RE: Response Letter
635 Sagamore Ave, Portsmouth, NH
Tax Map 222, Lot 19
JBE Project No. 18134.1

We are in receipt of comments from Eric Weinrieb, P.E., Altus Engineering dated August 28, 2024 and Stefanie Casella, Portsmouth Planning Department, dated August 31, 2024. Review comments are listed below with our responses in bold.

LANDSCAPE PLAN Plan Name:

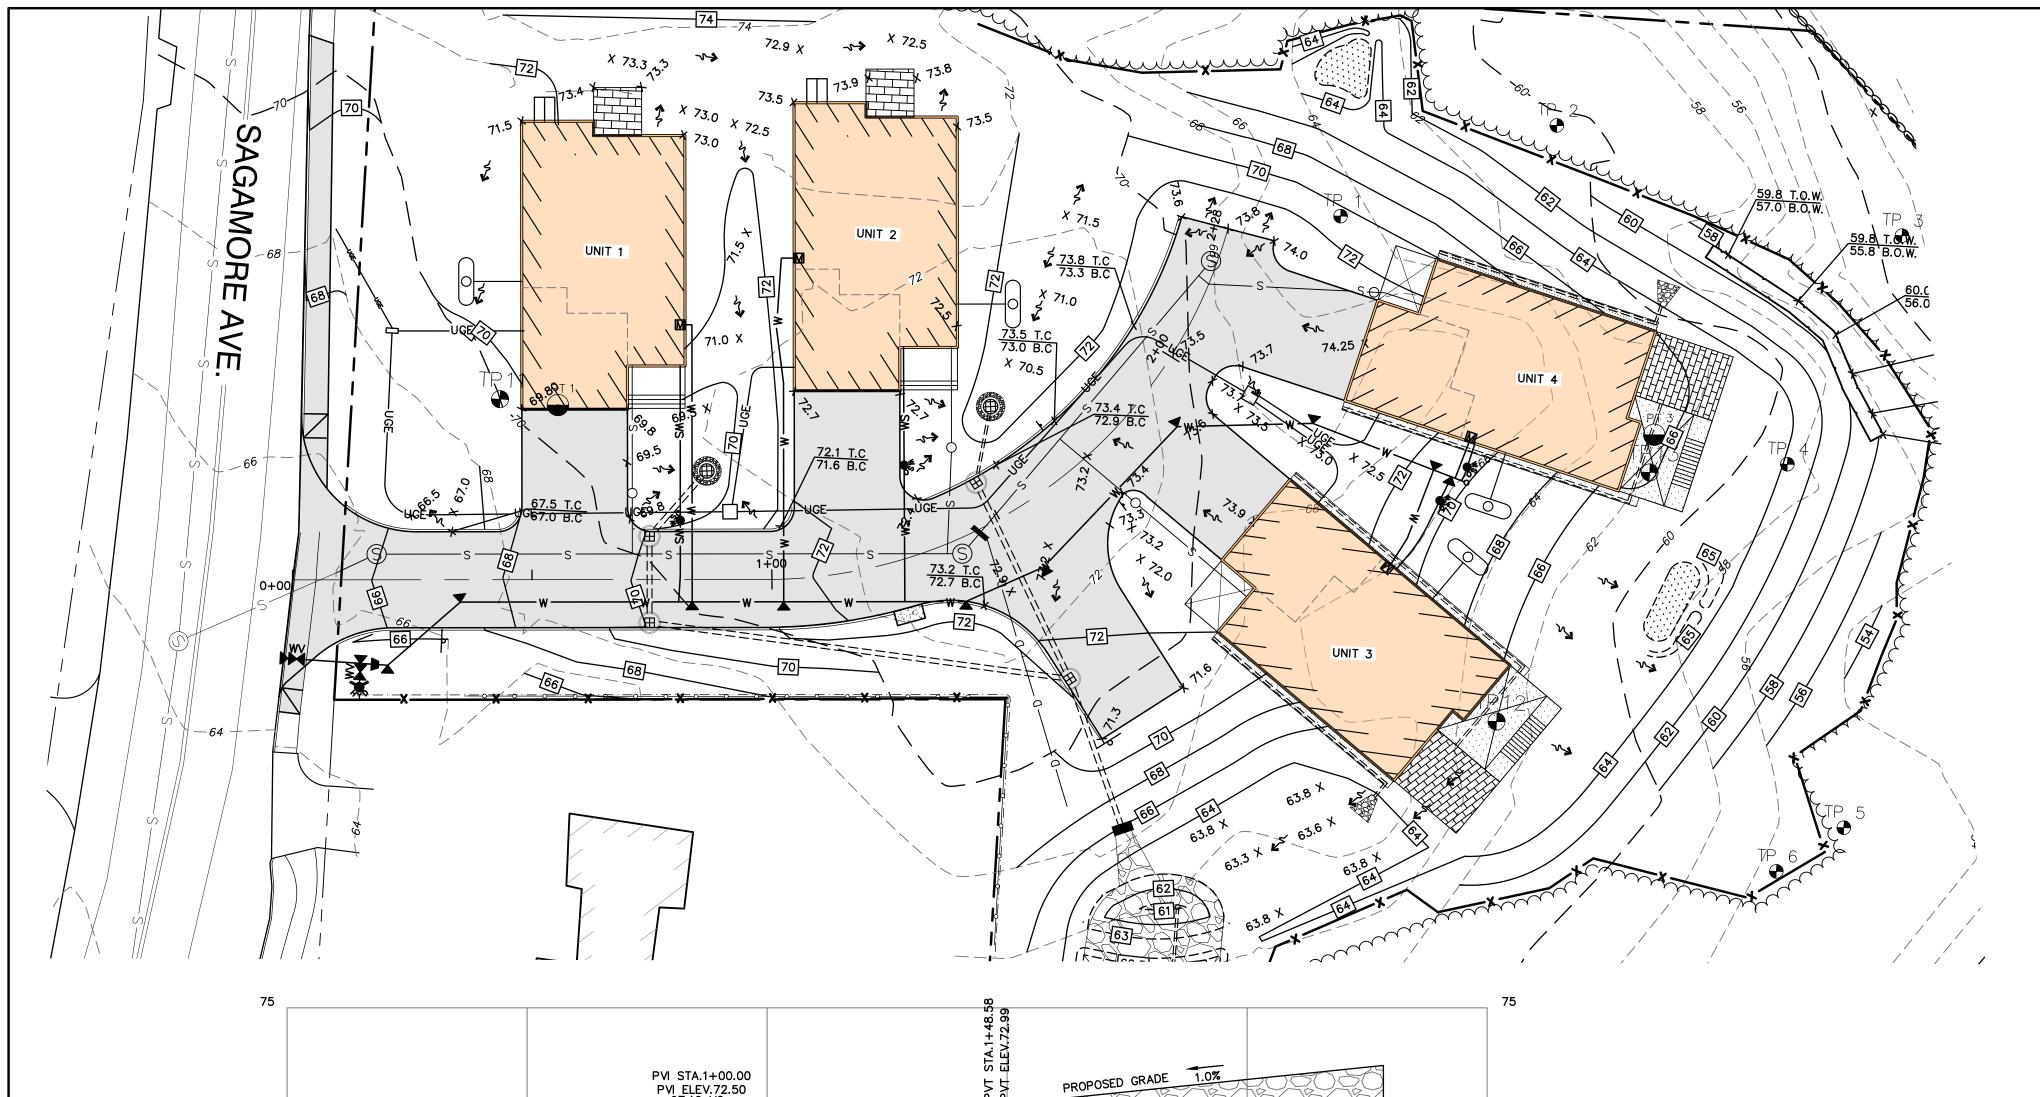
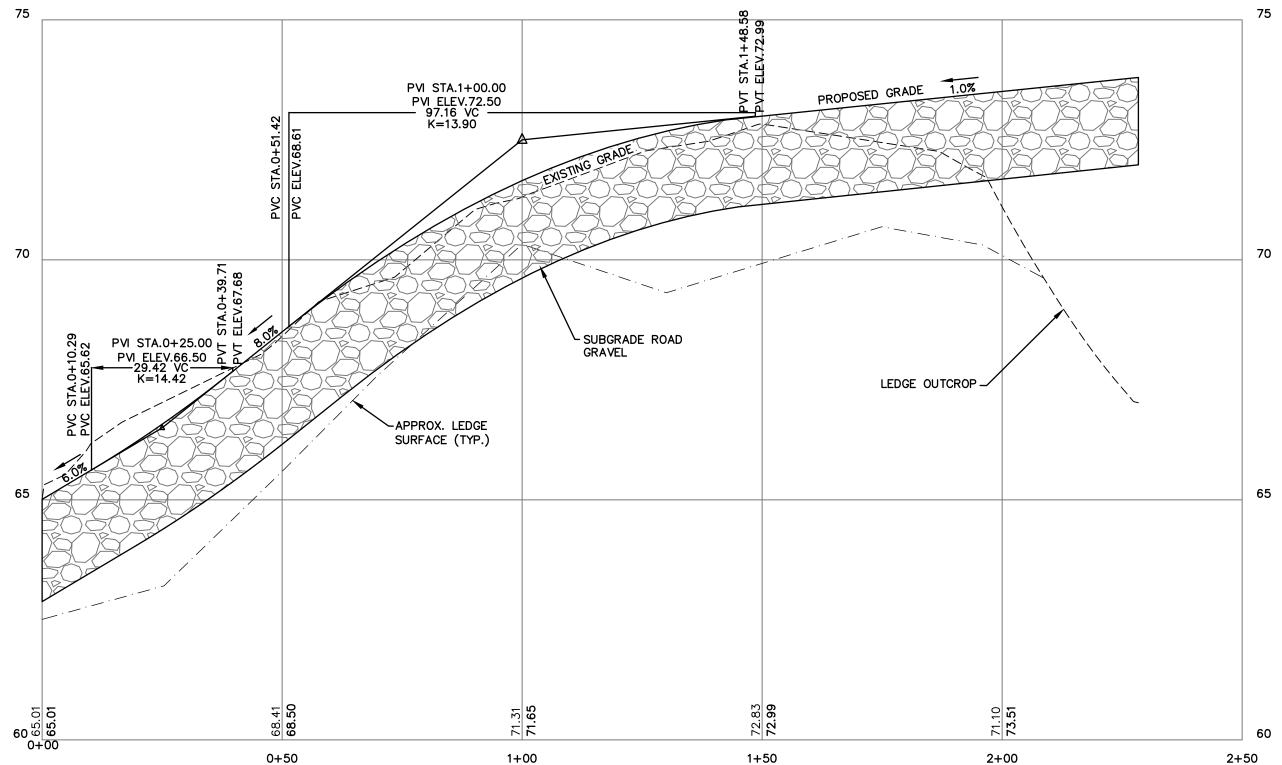
6. Proposed plantings are shown behind building units 1 and 2. There is mature vegetation in this area. The Designer and landscape architect should look at the existing vegetation to see if the existing buffer can be maintained and enhanced. Open issue. Altus recommends that there is at least three feet of soil below the plantings to improve survivability.

13. Landscape plan should comply with Portsmouth Site Plan Regulation Section 6.2.1 (C) and (D) and 6.2.2 (D).

Response: See Note #21 on Sheet L2 clarifying that ledge shall be removed to at least 3 feet below all below plantings for survivability or the plantings shall be raised with fill for 3 feet of separation to ledge in a way that will not obstruct flow patterns.

Response: Per Section 6.2.1(C), we are now showing the locations of all existing and proposed utilities faded back on the landscape plan. Per Section 6.2.1(D), we are also now showing building setbacks on the landscape plan. Per Section 6.2.2(D) we have added a "Growth habits" column to the planting schedule table.

"NO PARKING" SIGN (MUTCD R8-31)

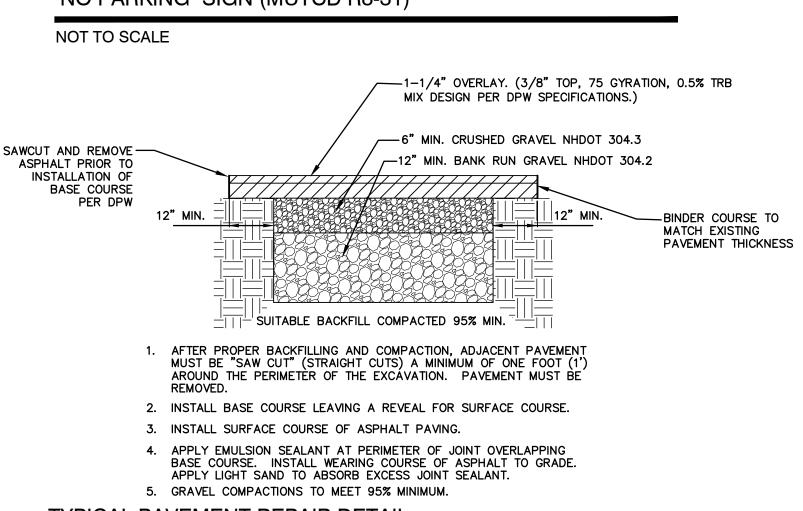
Response: Understood.
- 6. No Parking signs along the site driveway will be needed, at a minimum, between Sagamore Avenue and the driveway to Unit 1. The Fire Department may want the parking restrictions for a greater distance along the site driveway.

Response: No Parking signs have been added along the driveway and shown on Sheet C2.
- 7. Proposed architectural plans and elevations must be included in all submissions. Response: Proposed architectural plans and elevations are included with this resubmission and are part of the plan set.
- 8. Green building statement is required.

BLOW-OFF HYDRANT DETAIL

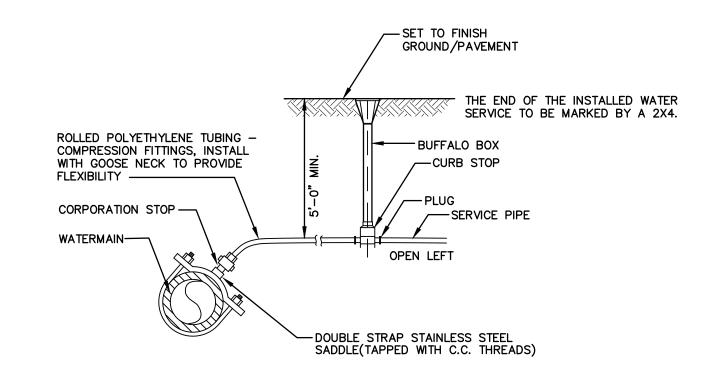
Response: We were previously proposing a blowoff at the end of the waterline. The word "hydrant" has been added. See Sheet C4. A detail for a blowoff hydrant has been added to Sheet D2.
- 3. State need for depth of sewer main. Depth at SMH 2 is approximately 10 feet deep. Response: We have raised the sewer main at this location and re-routed the drainage lines.
- 4. Include a 25 MPH advisory sign and blind driveway sign on Sagamore Avenue.
